Memo

From: Plan Review Committee of the Verona Environmental Commission

Re: **Case # 2021-01**
175 Grove Avenue [Block 1101, Lot 6.01]
Verona, New Jersey

The Plan Review Committee of the Verona Environmental Commission (VEC) reviewed the application for 175 Grove Avenue in Verona submitted by Ms. Seneta Whiting, which we received on January 25, 2021. We understand that the Applicant is seeking to obtain a variance to exceed the maximum allowable total lot coverage for that zone. The comments below are provided for the Board's consideration:

3

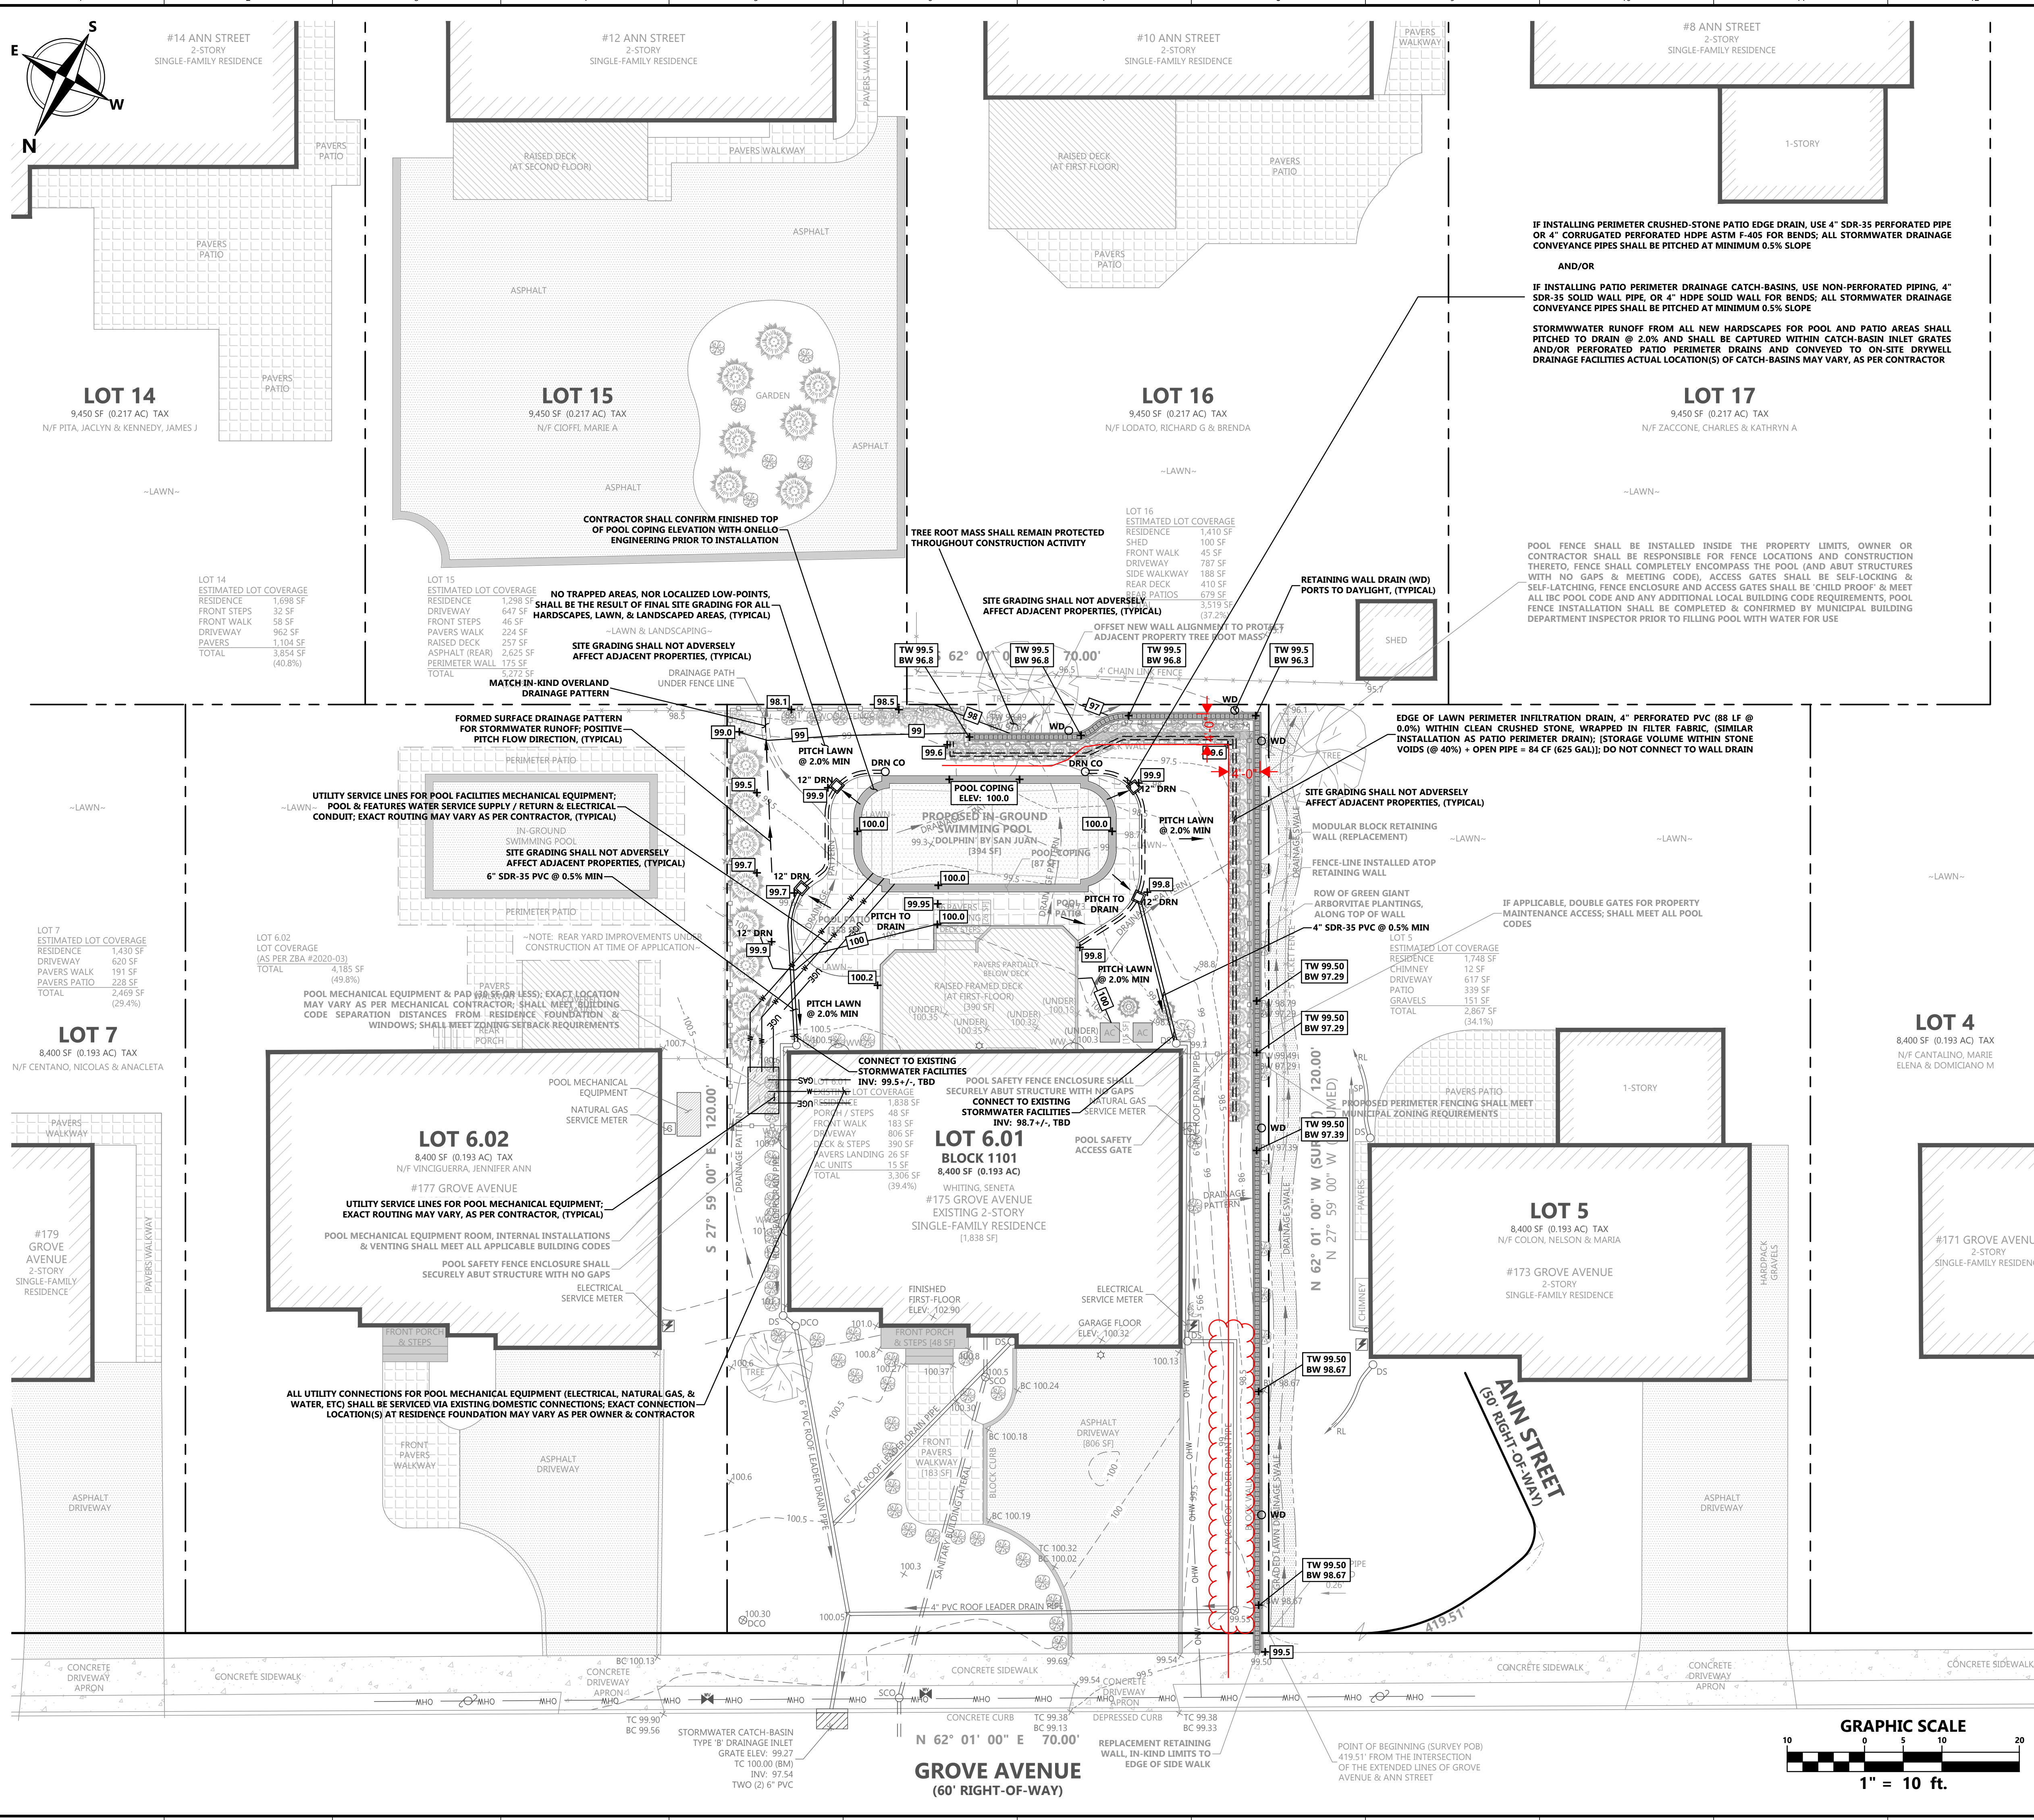
- 2) Existing and Proposed Improved Lot Coverage is listed as 39.36% and 49.75% on the application, respectively. Scaling off the drawing, we calculated an Existing Improved Lot Coverage of 41.0% based on an Existing "Improved Area" of 3,444.1 ft² (please see attached annotated pdf). Furthermore, we calculated a Proposed Improved Lot Coverage of 51.5% based on a Proposed "Improved Area" of 4,322.9 ft². We understand that the maximum Improved Lot Coverage for the R-60 Zone is 40%.

Areas (scaled off plan)
Lot size = 8,400 I2
Existing "Improved Area" = 1,880.5 (I) + 983.1 (II) + 414.3 (III) + 145.0 (IV) + 12.5 (V) + 8.7 (VI) = 3,444.1 I2
Existing Improved Lot Coverage = 3,444.1 ÷ 8,400 = 41.0%
Proposed "Improved Area" = 3,444.1 - 145.0 (IV) + 843.4 (VII) + 156.4 (VIII) + 24 (IX) = 4,322.9 I2
Proposed Improved Lot Coverage = 4,322.9 ÷ 8,400 = 51.5%
Definitions:
IMPROVED LOT COVERAGE = The percentage of lot area which is improved with principal and accessory buildings and structures, including all impervious surface areas such as buildings, driveways, parking lots and garages and other man-made improvements, and swimming pools.
PERVIOUS INTERLOCKING PAVERS = Any pavers with a void area of 20% or less will be considered completely impervious for the purposes of the Stormwater Management rules. In pavers with greater than 20% void area, the applicant may count only the non-void area as impervious, provided the void areas are not grouted or made impermeable in any way.

MODULAR BLOCK RETAINING WALL DETAIL

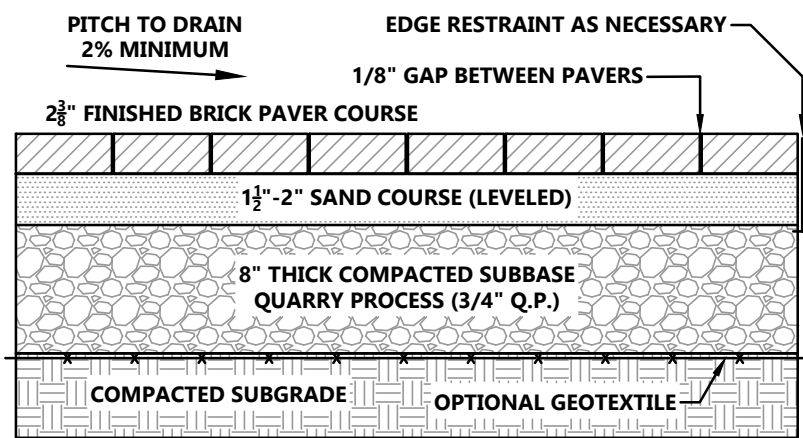
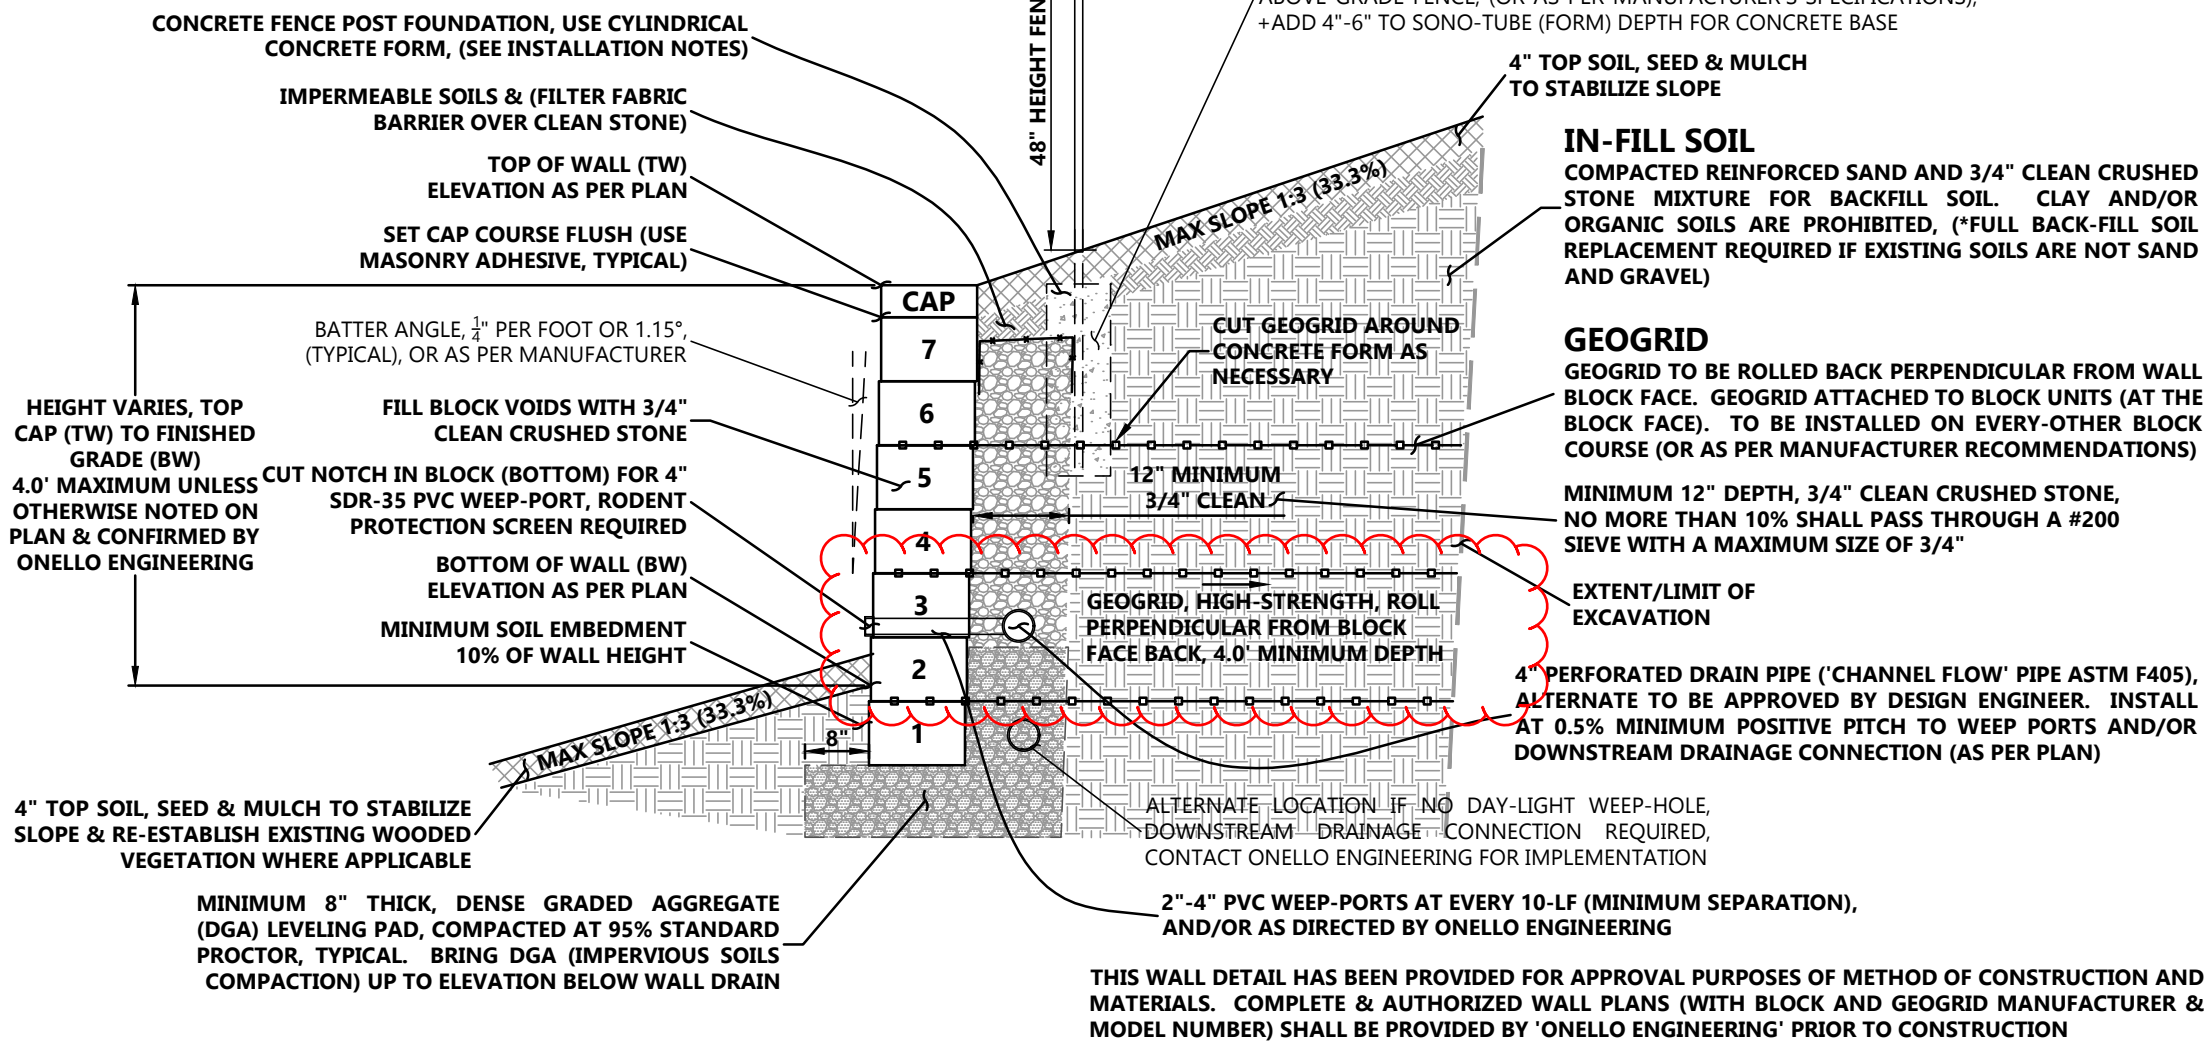
- 7) The modular block retaining wall details on Onello Engineering Dwg. No. 6 indicate that the reinforced soil zone with geogrid will be 4 feet from the face of the wall. The Applicant's design professional should check for a conflict of the construction of the reinforced soil zone and the 4-inch PVC Roof Leader Drain Line along the northeast corner of the property.
